**STAFF RECOMMENDATION**  
**1717 Villa Place**  
**February 19, 2019**

**Application:** Partial Demolition; New Construction—Addition  
**District:** Edgehill Neighborhood Conservation Zoning Overlay  
**Council District:** 17  
**Base Zoning:** RS5  
**Map and Parcel Number:** 10408035900  
**Applicant:** Trent Dabbs, Owner  
**Project Lead:** Sean Alexander, sean.alexander@nashville.gov

1717 Villa Place, front.

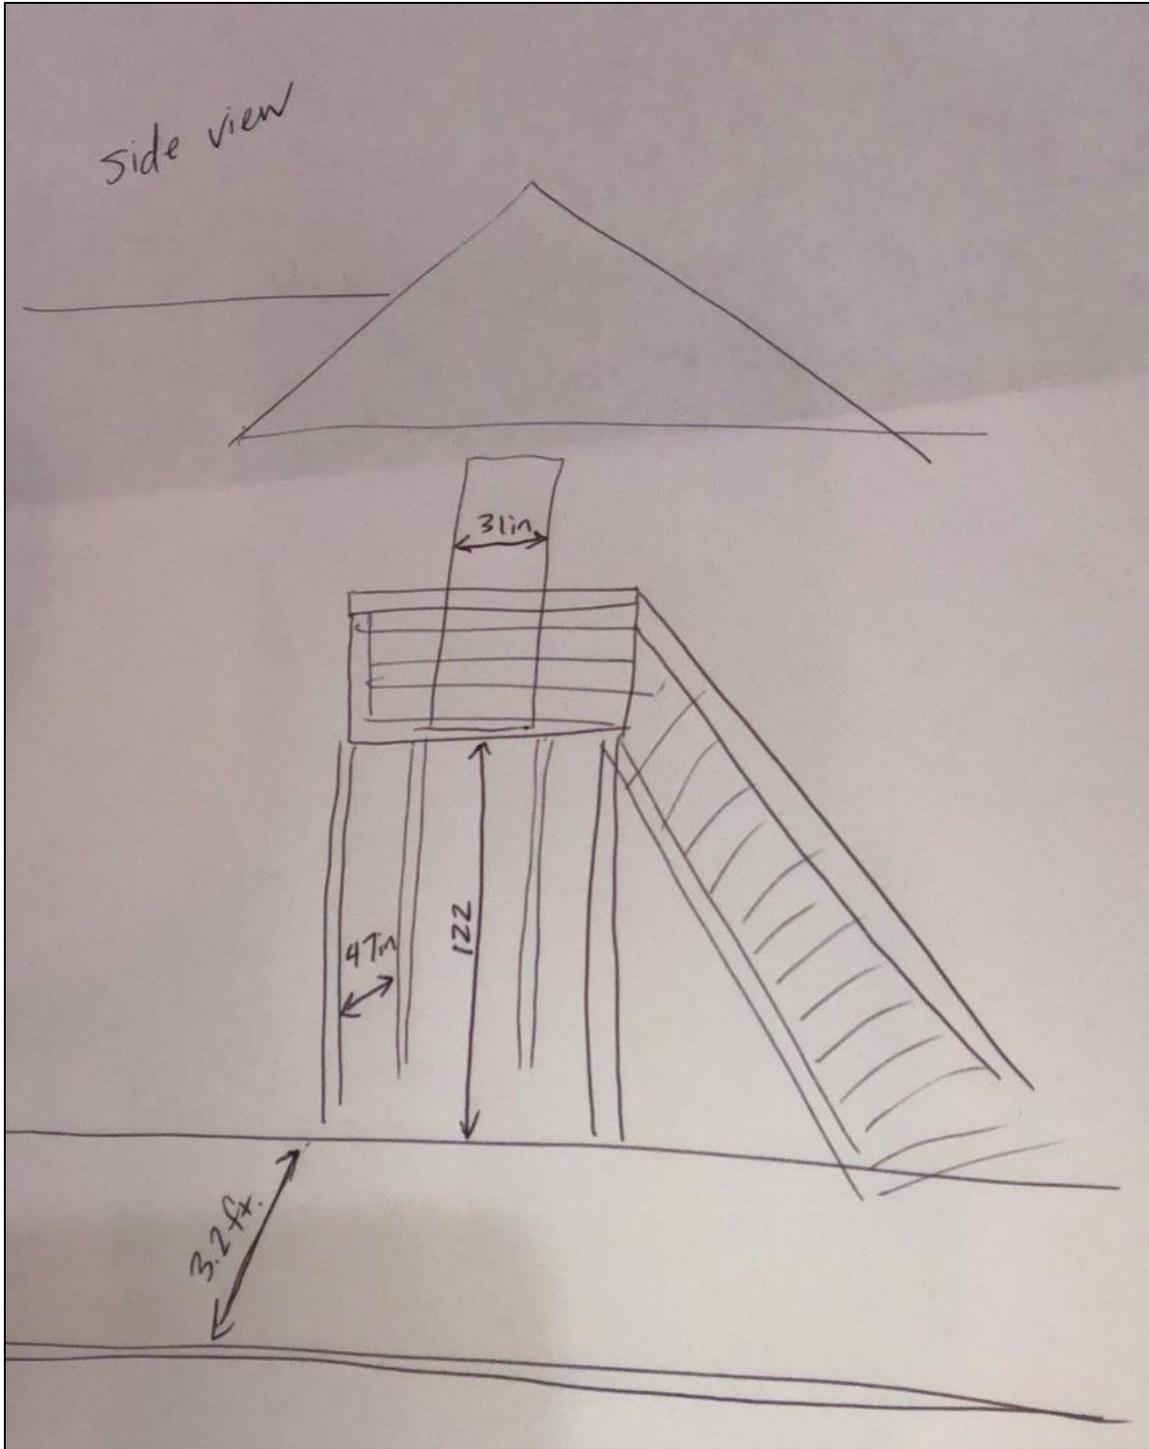
**Analysis and Findings:** The applicant is seeking after-the-fact approval of a new open exterior staircase that was added on the left side of the house, and a window opening in the left gable wall that was converted to a doorway. The applicant did not acquire a Building Permit or Preservation Permit for this work.

Staff finds that the partial demolition of the left side wall to convert the window opening into a doorway does not meet Section VI.B.2 for appropriate demolition, and that it constitutes an inappropriate demolition under section VI.B.1.

Location & Removability: The new uncovered exterior staircase was added on the left side of the house, originating approximately five feet (5') back from the front wall of the building and leading up to the new door in the center of the gable-field wall. Exterior stairs are not typical of historic Craftsman style buildings and so are not appropriate unless located at the rear, where they would not be visible or would be only minimally visible.

Additionally, the location of the stair runs across the opening of an original and remaining window opening on the first story. Additions should not disturb side facades or remove or obscure architectural features.

Staff finds that the location and attachment of the stair addition is not appropriate and does not meet Sections V.A, V.B, and V.C. of the Edgehill design guidelines.

Design: The new stairs are wood with solid risers and a wood and steel cable railing, which is relatively modern in design and contrasts with the character of the Craftsman style house. Modern additions are not discouraged when they are compatible with the historic property, do not remove original materials, or are minimally visible. The recently constructed stairs are in a highly visible location, are not consistent with the Craftsman style of the house, and required the removal of a portion of the gable wall.

Staff finds that the stair and window alteration do not meet Section V.A, V.B., IV.C., and IV. F. of the Edgehill design guidelines.

While removing the risers on the stairs would meet the setback requirement, Staff finds that the location of the stairs with or without risers is not appropriate with the historic context because they alter the appearance of the house and the space between houses.

Staff finds that the stairs do not meet Section III.C. of the Edgehill design guidelines for setback and rhythm of spacing.

Although the materials of the stair and door may be appropriate in other applications, Staff finds that they are not appropriate for a highly visible addition on an historic building and therefore do not meet Section III.D. of the Edgehill design guidelines.

**Recommendation:** Staff recommends disapproval of the request for after-the-fact approval to retain the exterior staircase and window alteration on the left side of the house at 1717 Villa Place and that original conditions be returned within 30 days, finding that the work does not meet the following sections of the Edgehill Neighborhood Conservation Zoning Overlay design guidelines:

Staff further recommends that the replacement window, once the door is removed, is approved administratively.
